FS103–06/07

715.3 (New), 715.3.1 (New), 715.3.2 (New), 715.3.3 (New)

Proponent: Kate Steel, representing Fire & Safety Glazing Council

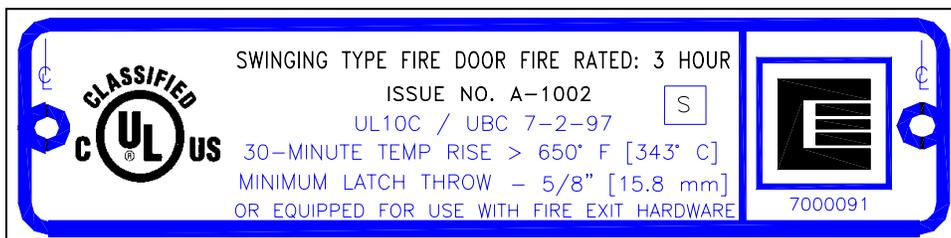
Revise as follows:

Reason: As written, Section 715.3.5 does not accurately define what is the standard labeling practice employed by fire door manufactures.

715.4.5.1 Fire door labeling requirements. Fire doors shall be labeled showing the name of the manufacturer or other identification readily traceable back to the manufacturer, the name or logo of the third-party inspection agency, the fire protection rating and, where required for fire doors in exit enclosures and exit passageways by Section 715.4.4, the maximum transmitted temperature end point. Smoke and draft control doors complying with UL 1784 shall be labeled as such and shall also comply with Section 715.4.5.3. Labels shall be approved and permanently affixed. The label shall be applied at the factory or location where fabrication and assembly are performed.
